**CITY OF TULARE PLANNING COMMISSION  
STAFF REPORT**

April 9, 2018

**KENSINGTON ESTATES – TENTATIVE SUBDIVISION MAP  
CONDITIONAL USE PERMIT NO. 2017-17  
ZONE AMENDMENT NO. 722**

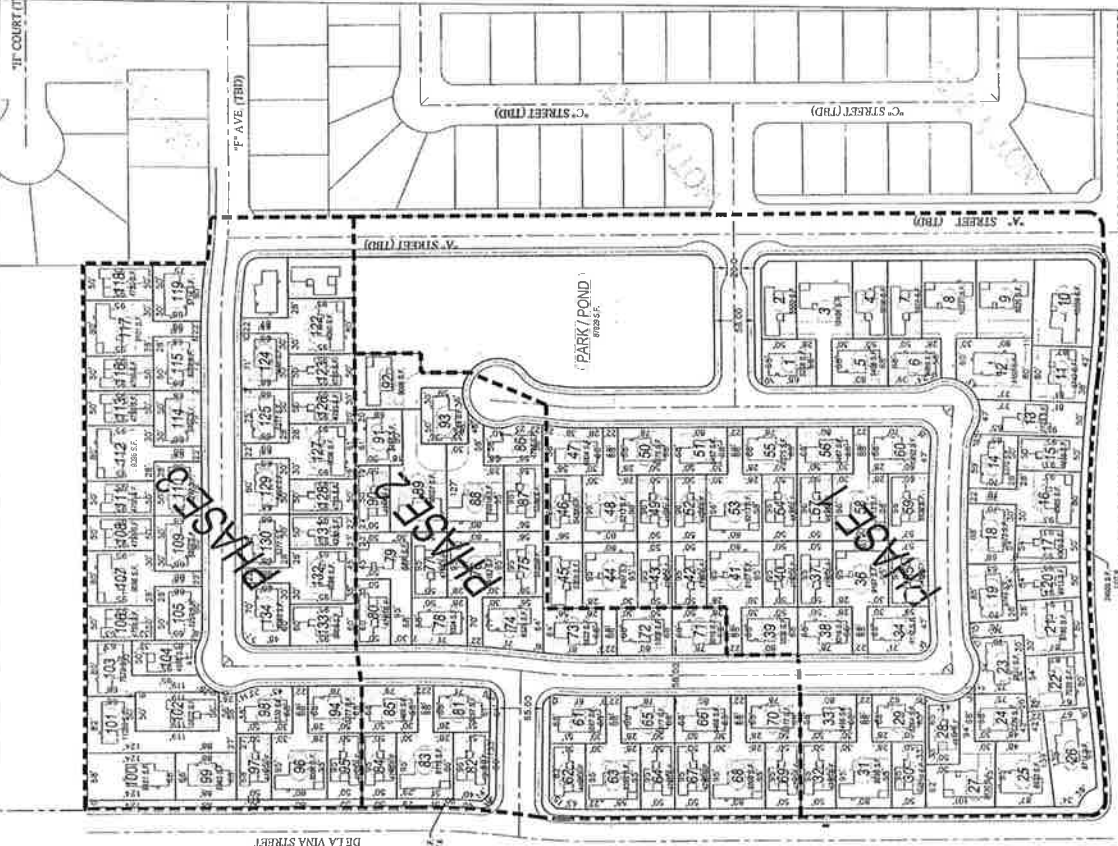
In conformance with City Standard Detail 7020, the typical 58' R/W cross section on the tentative map should include 11' of R/W behind face of curb consisting of 5' wide sidewalk and a 5.5' parkway width with the remaining 0.5' being top of curb width. The most recent version of the tentative map submitted shows only 10' of R/W behind face of curb.

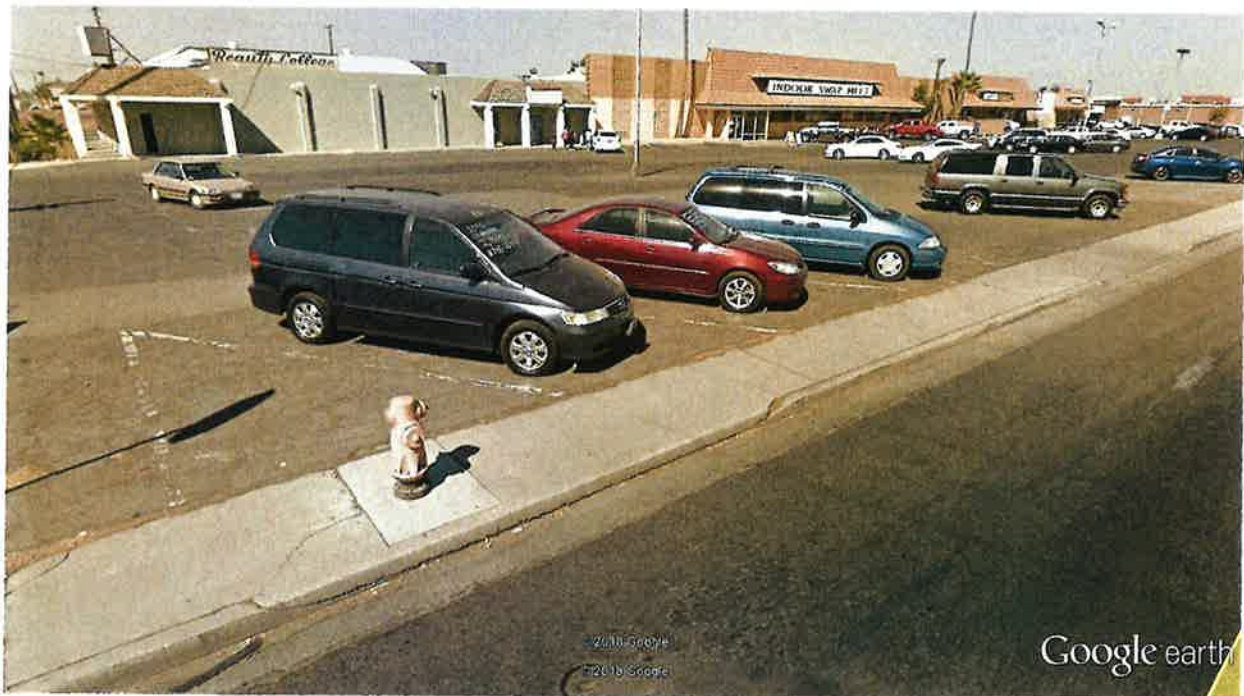
West Street – West side north of curb return at Inyo Avenue. Modification of old driveway approach with barrier curb is failing with severe cracking in curb and gutter, minor cracking in sidewalk.

West Street – West side south of driveway approach at north end of project site. Major cracking in curb and gutter and moderate cracking in expansion joints of sidewalk.

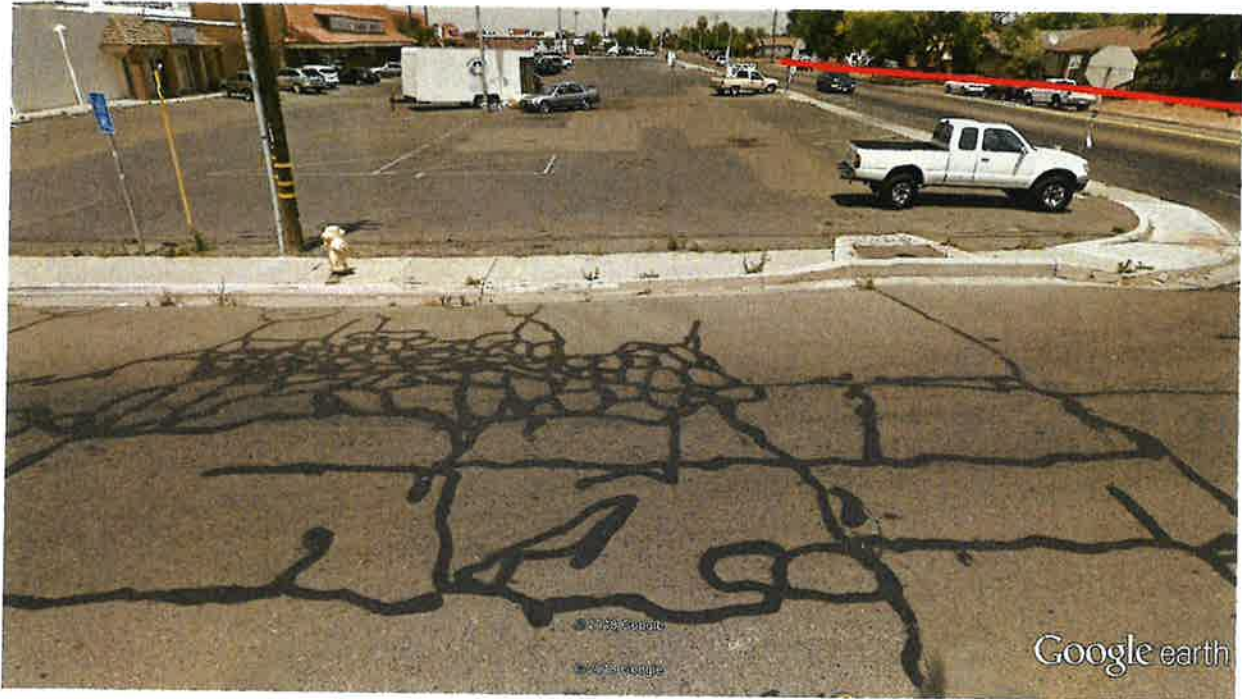
West Street – Driveway approach at north end of project site. Major cracking in curb and gutter and driveway approach. No accessible path of travel behind driveway approach.

Inyo Avenue (State Route 137) – North side between driveway approach and West Street. Improvements to curb, gutter and sidewalk as required by Caltrans.
